MONROE COUNTY DRAINAGE BOARD

AGENDA

1. Call to Order
2. Approval of Minutes for: November 1, 2023 and December 6, 2023 +*
3. Public Input for Items not on the Agenda
4. Business
 - a. PUO-23-6 Preliminary Drainage Plan: North Park II B-9 Fill Site – Karst updates +

- b. SPP-23-3 Preliminary Drainage Plan: North Park Area B-3 Lot 3 – Stone Carver Drive +*
 - c. Drainage Easement Waiver Request (after-the-fact): 408 W Irie Ct. (Southern Meadows Lot 60) +*

Overall Grading Plan:

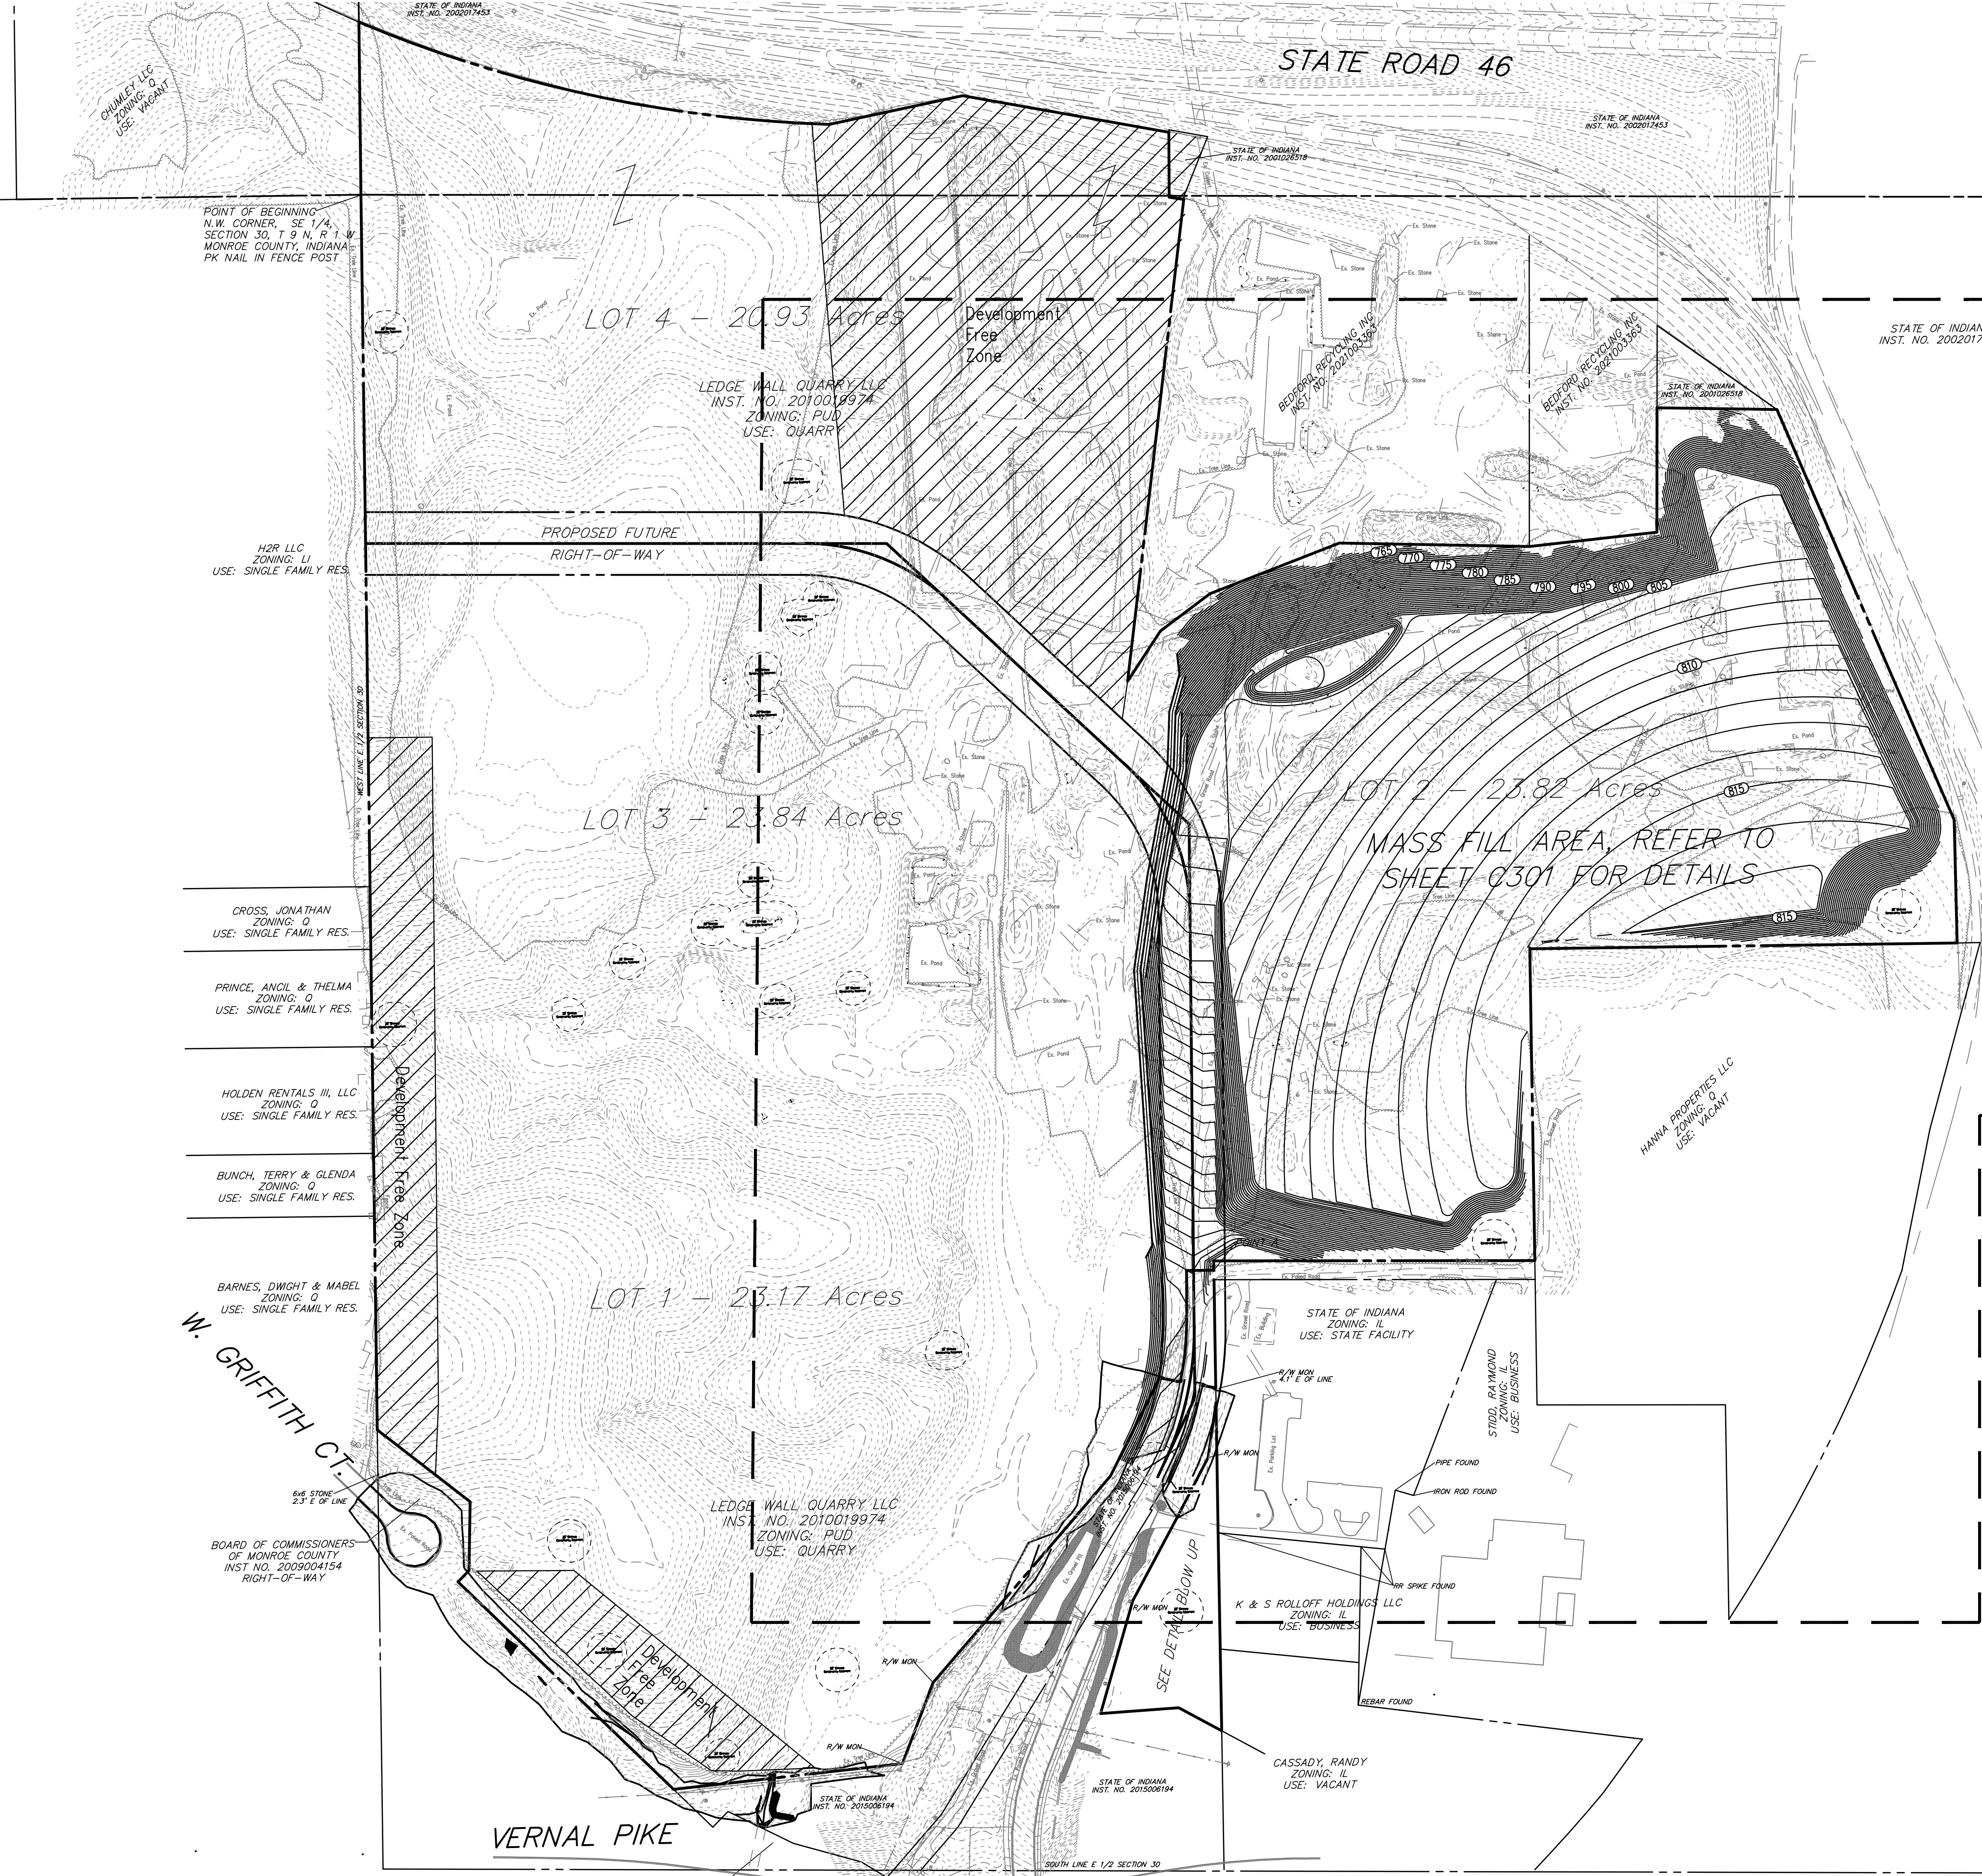
- The proposed temporary sediment basin is shown roughly 40 feet above existing grade. This is fine for later fill operations, but I need to see a plan for temporary sediment traps to be installed prior to any fill operations beginning. Since this will be a large long-term operation, there should be sediment traps along the toe of the slope to capture erosion from the fill area during different phases of the project.
- Provide benches along the slope in the final grading plan.
- Silt fence is not an adequate practice to capture runoff from a 30-40 ft 3:1 slope. Pipe slope drains may be a good practice to convey water from the top of the pile to sediment traps at the toe of the slope.
- Provide drainage calculations showing the capacity/adequacy of the sediment traps.
- A natural buffer of 50 feet must be provided on either side of the main south-north stream channel.

- Provide a final stabilization plan including topsoil/seed (specify depth of topsoil), wattles along the slopes, and description of the phasing/sequencing.

Figure 10. Spring Box
Source INDOT

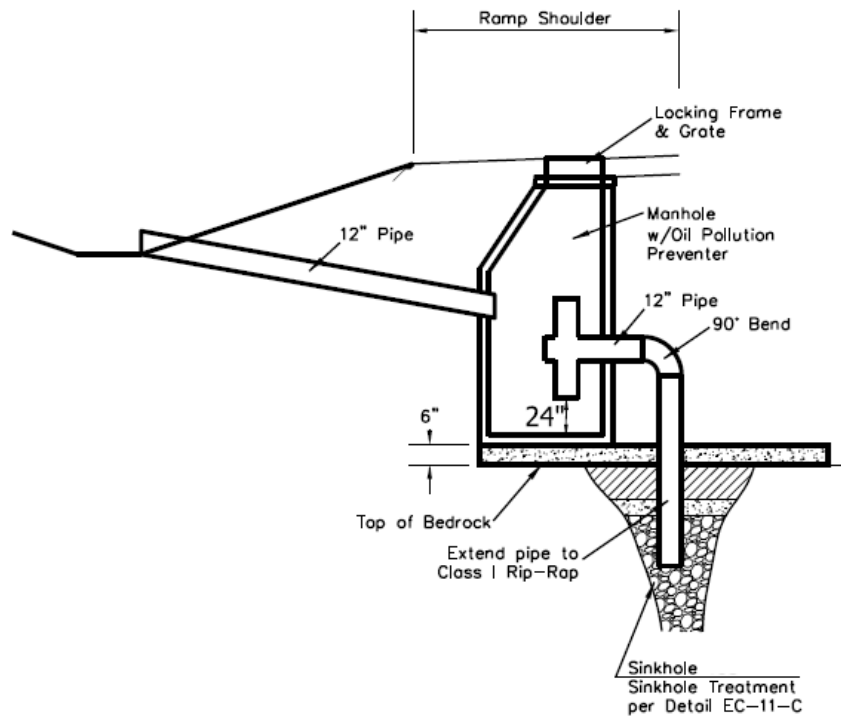
- **Jason provided an example detail sheet of a spring box from INDOT's manual 'Protection of Karst Features during Project Development and Construction' dated July 2021.**

**AS-BUILT PLAN
LOT 60 SOUTHER MEADOWS PHASE 2
(408 W IRIE COURT)**

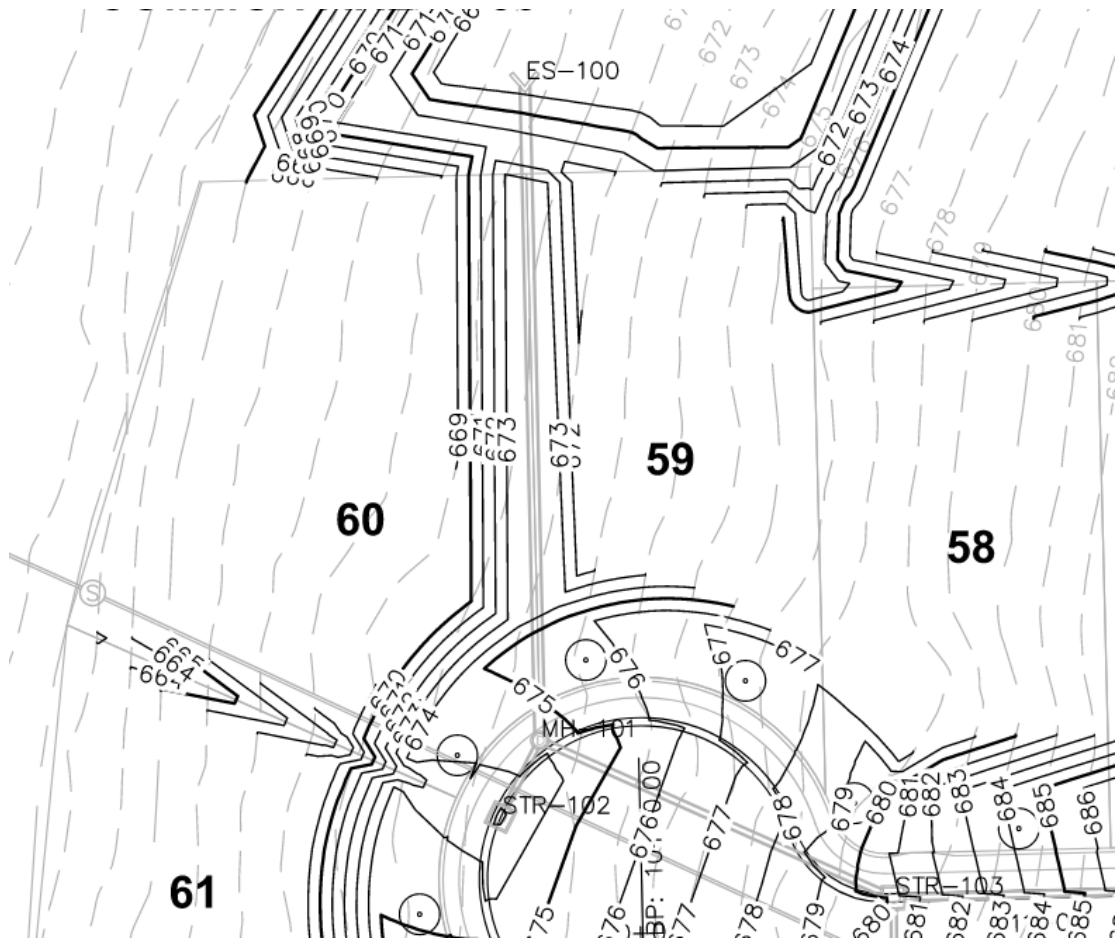
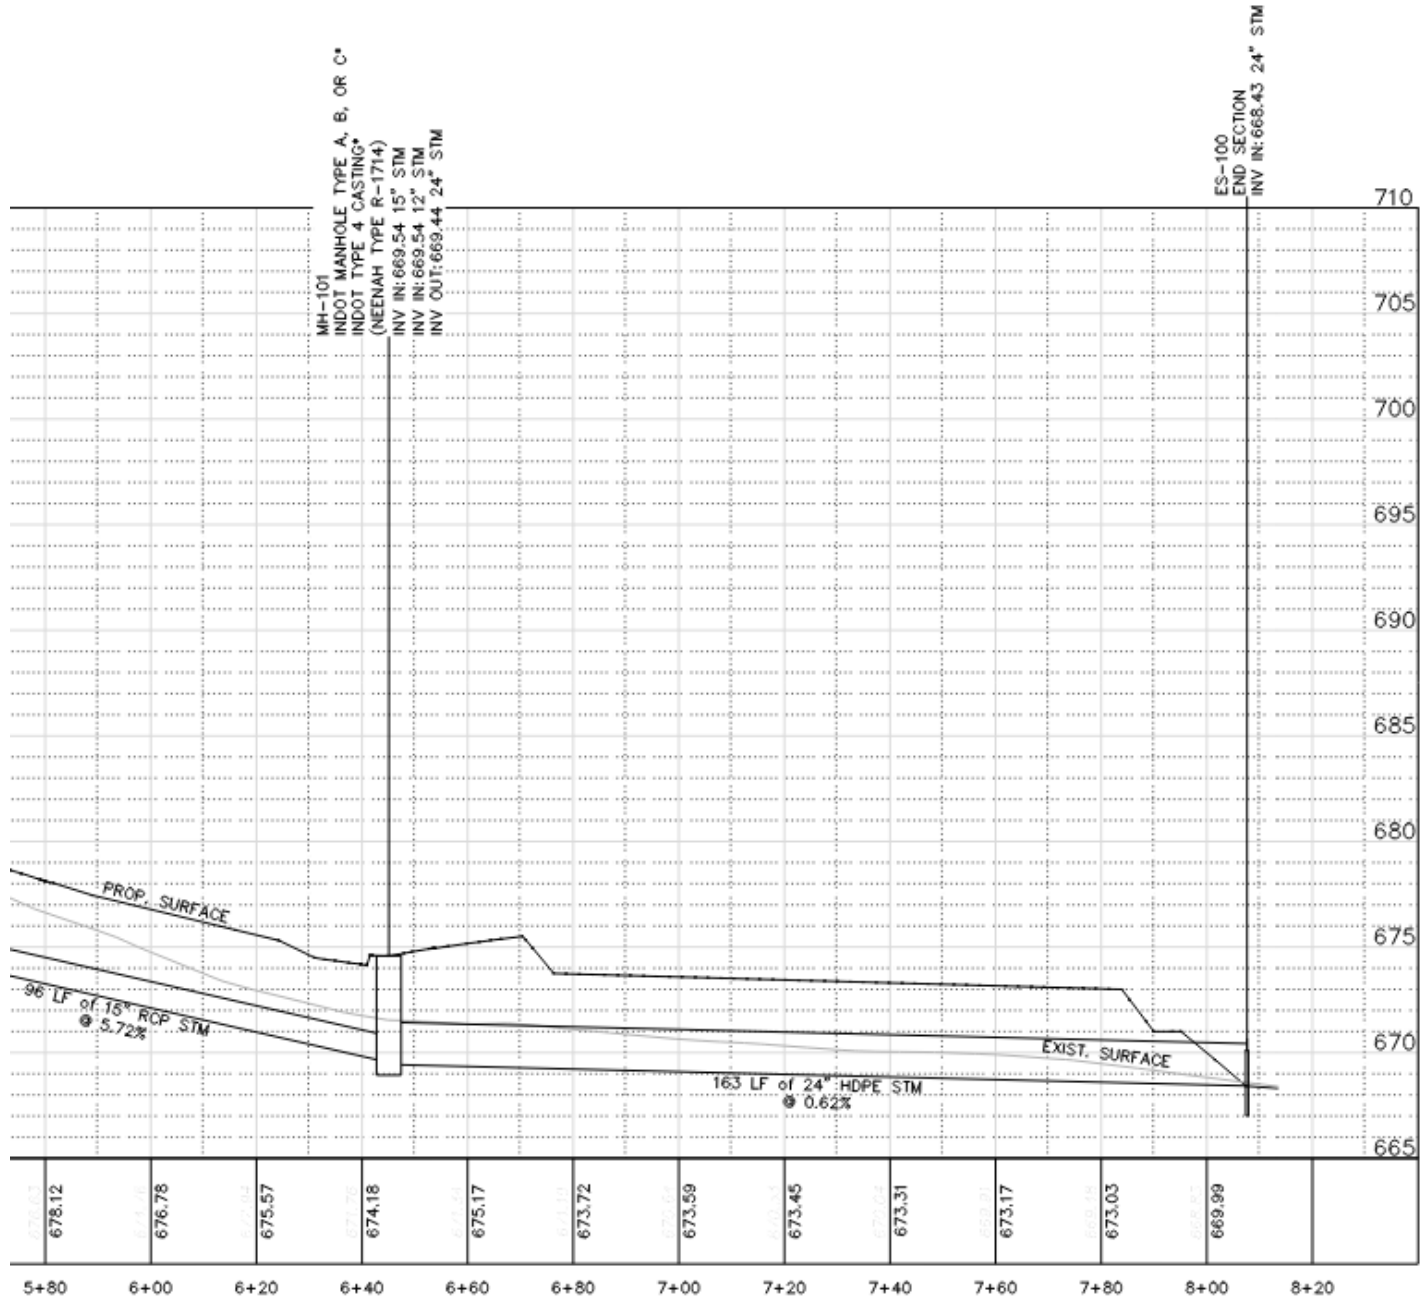
At 408 W Irie Ct., the property owner installed a fence within a 20 ft. drainage easement over an HDPE storm pipe. The property owner inspected the pipe themselves and provided video footage. They found the survey stake at the corner of the property punctured the pipe but no damage from fence posts was observed. At the November 2023 meeting, there was a comment made about the issue of potential settling. The pipe was laid on native soil (not new fill) as shown on the storm sewer profile.

Lot 60. Photo of survey stake at property corner punctured HDPE storm pipe.

**AS-BUILT PLAN
LOT 58 SOUTHER MEADOWS
PHASE 2
(404 W IRIE COURT)**

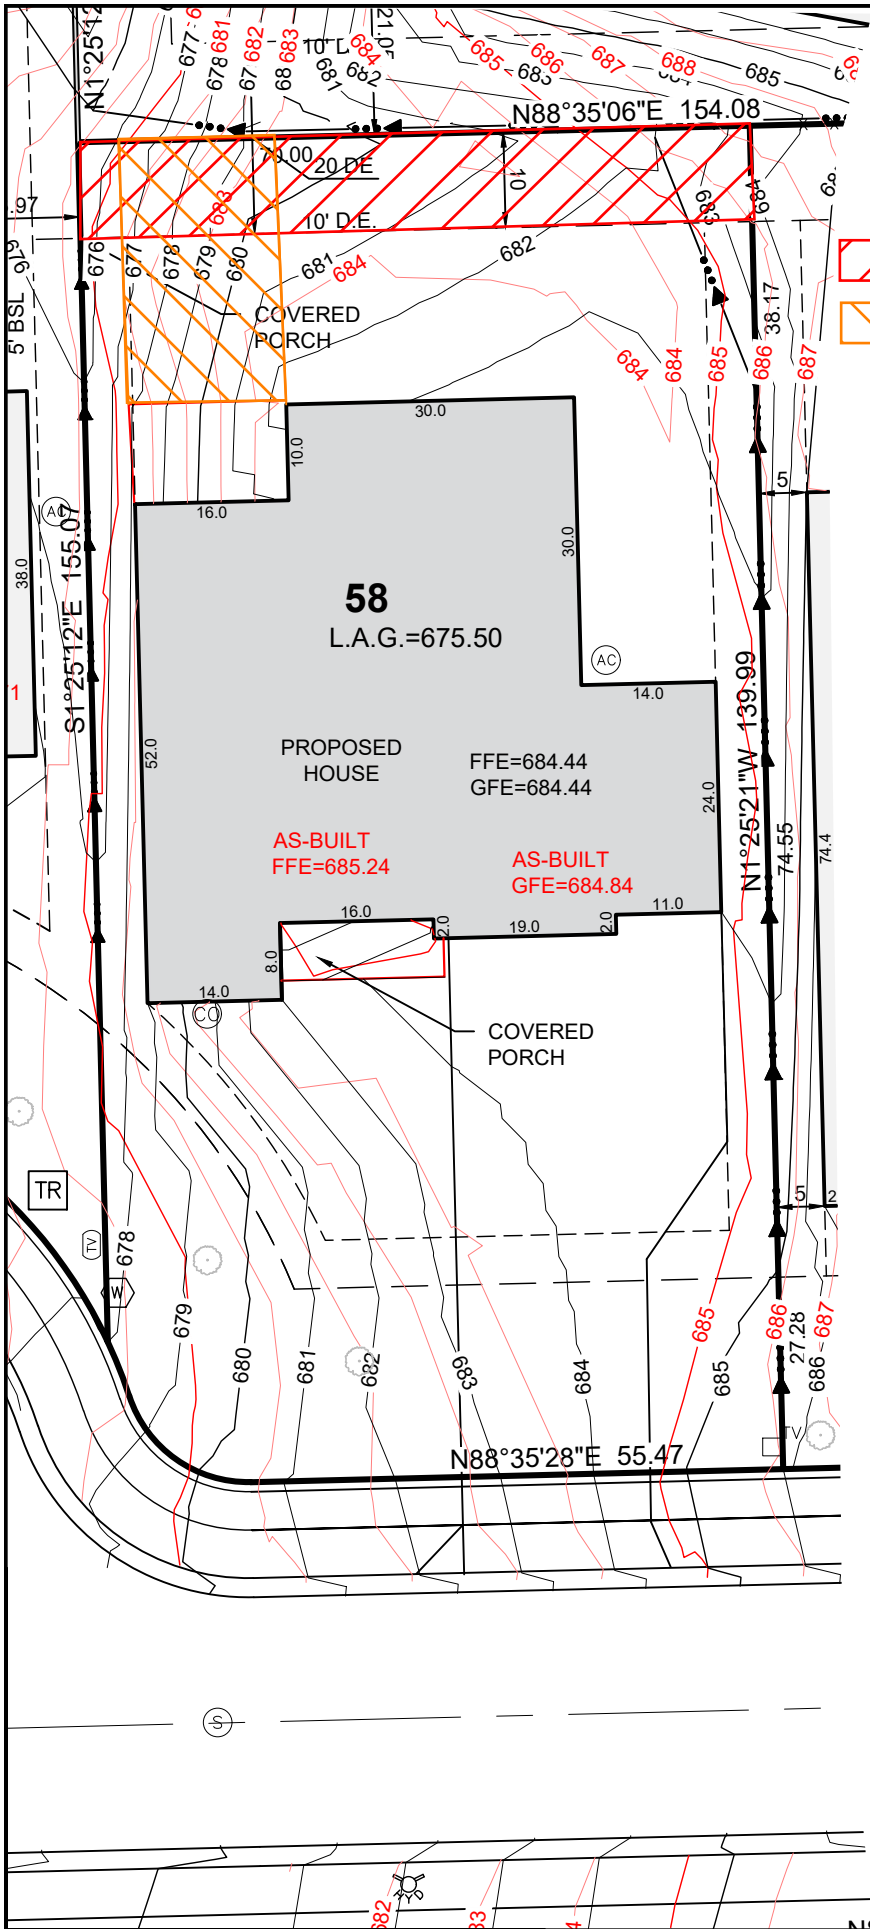
At 404 W Irie Ct., the property owner installed a deck within a 20 ft. drainage easement that serves as an emergency overflow for the seven sag inlets on Abington Ave. and drains the rear/side yards of Lots 57 and 56. The emergency overflow drainage easement was not graded to the original drainage easement grading plan, and corrections were made on Lot 57. The grading of the rear yard and easement on Lot 58 still does not appear to meet the original grading plans, but there is a fair amount of elevation change in this area. The property owner also received a violation letter from the Building and Planning Departments because its height, over 30", should have been permitted by the Building Department prior to construction.
